WELL API NO. 30-025-26954
5. Indicate Type of Lease STATE <input checked="" type="checkbox"/> FEE <input type="checkbox"/>
6. State Oil & Gas Lease No.
7. Lease Name or Unit Agreement Name BOBBI STATE WATERFLOOD UNIT
8. Well Number 3
9. OGRID Number 232611
10. Pool name or Wildcat Arkansas Junction-San Andres West
11. Elevation (Show whether DR, RKB, RT, GR, etc.) 3835' GRD

SUNDRY NOTICES AND REPORTS ON WELLS
(DO NOT USE THIS FORM FOR PROPOSALS TO DRILL OR TO DEEPEN OR PLUG BACK TO A DIFFERENT RESERVOIR. USE "APPLICATION FOR PERMIT" (FORM C-101) FOR SUCH PROPOSALS.)

WELL DATA SHEET

LEASE: BOBBI STATE WATERFLOOD UNIT **WELL:** 3 **FIELD:** ARKANSAS JUNCTION (SAN ANDRES)
LOC: 330' FSL & 2310' FWL **Fed, State, Fee:** STATE **Unit: N Sec: 20 Township: 18S Range: 36E**
STATUS: TA **CO:** LEA **API NO:** 30-025-26954
TD: 5700' **ST:** NEW MEXICO **LEASE #**
PBTD: _____ **WFU R-13731**
COTD: _____

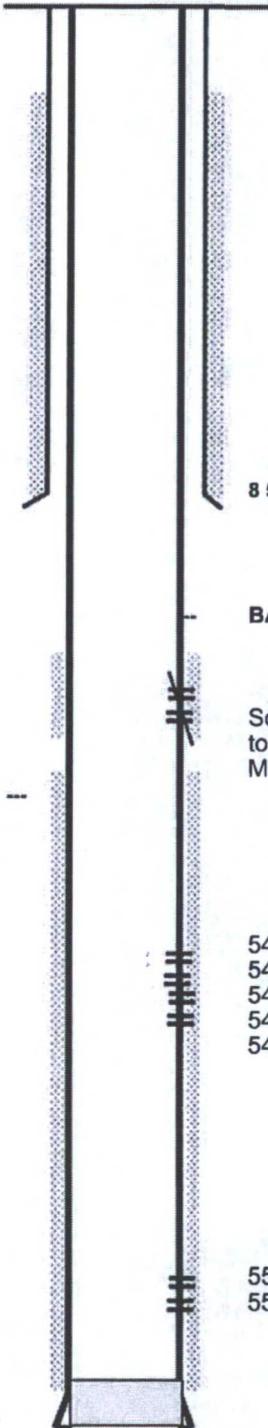
Attempt was made to put well back into production- Casing issues at 2 spots above perforations after CIBPs were drilled out- Sundown proposes to set CIBP above bad casing at approximately 2500' and TA well until well can be re-drilled utilizing exosting 1890' of surface casing for Water Flood Producer.

BAD CASING INDICATED AT 3907' & 4326' →

→ 3300' OR DEEPER AS WELL CONDITIONS WILL ALLOW. MIB

State Inspector will be notified and CIBP and casing tested to 500# or as directed with chart recorder.

B.O.S
3224 +/- T. of YATES
3258'

Condition of Approval: notify

OCD Hobbs office 24 hours prior of running MIT Test & Chart
